INFORMATION SHEET

BUILDING SERVICES

Ref: BCA 19-01
Current at January 2019

AS/NZS 3000: 2018 – Changes to Wiring Rules Standard

FIGURE 4.17 PROHIBITED LOCATION FOR SOCKET-OUTLETS AND SWITCHES INSTALLED NEAR OPEN COOKING SURFACES (GAS OR ELECTRIC)

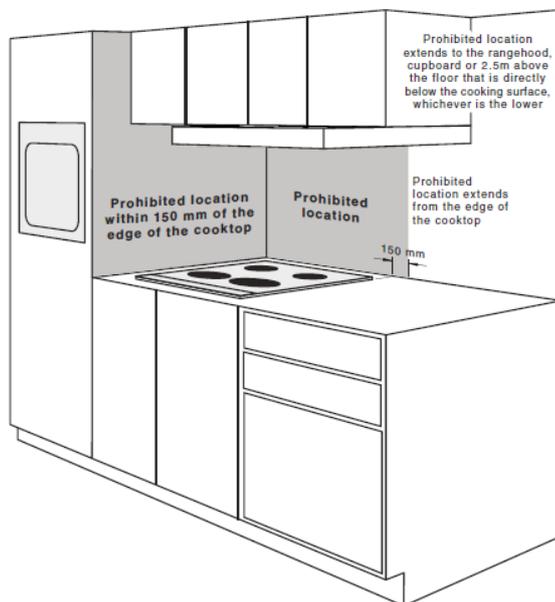
A new clause 4.7.3 requires an exclusion zone of 150mm horizontally and a vertical height determined by the kitchen layout. No socket outlets or light switches can be installed in the exclusion zones identified by the figure shown below.

This new clause is required to ensure electric powered cooktops have the same requirements as the Gas Standard which applies to the installation of a gas powered appliance (AS/NZS 5601).

FIGURE 5.9 EXAMPLE OF BONDING ARRANGEMENT FOR POOLS AND SPAS

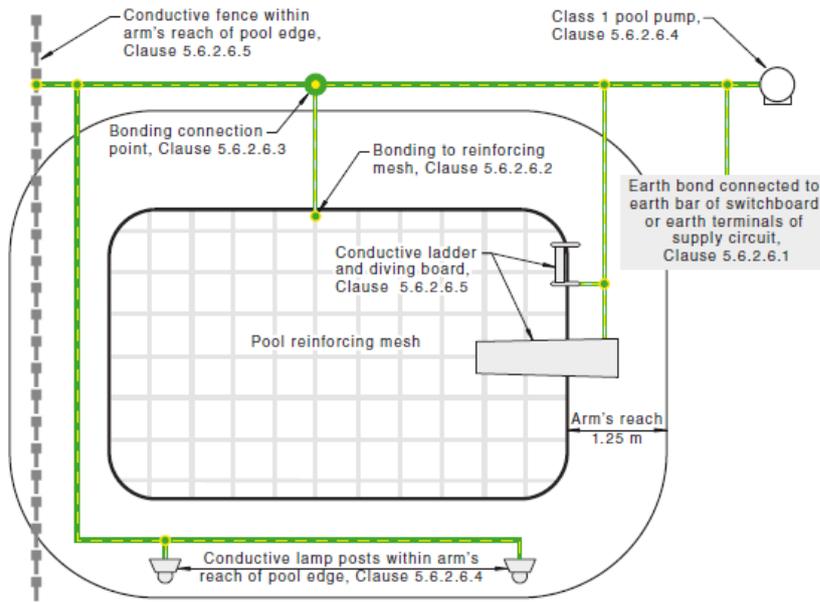
A new diagram, Figure 5.9, illustrating one method of constructing a bonded earthing system to meet the requirements of equipotential bonding has been added. Note that the pool reinforcing tail to be connected to the general earthing conductors require that termination to be accessible. All other tails from the required earthing of fittings and fixtures need not be accessible.

FIGURE 6.13 ZONE DIMENSIONS FOR OTHER FIXED WATER CONTAINERS WITH FIXED WATER OUTLETS WHERE NO CONTAINER HAS A CAPACITY EXCEEDING 40 L

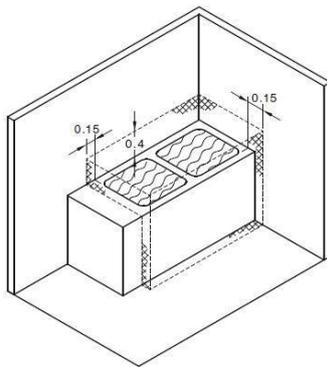
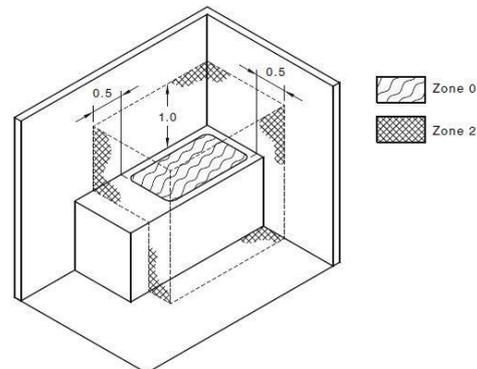
Figures 6.13 and 6.14 illustrate a change to a 40 litre capacity from the previous 45 litres for the purposes of determining exclusion zones (where socket outlets and light switches cannot be installed)
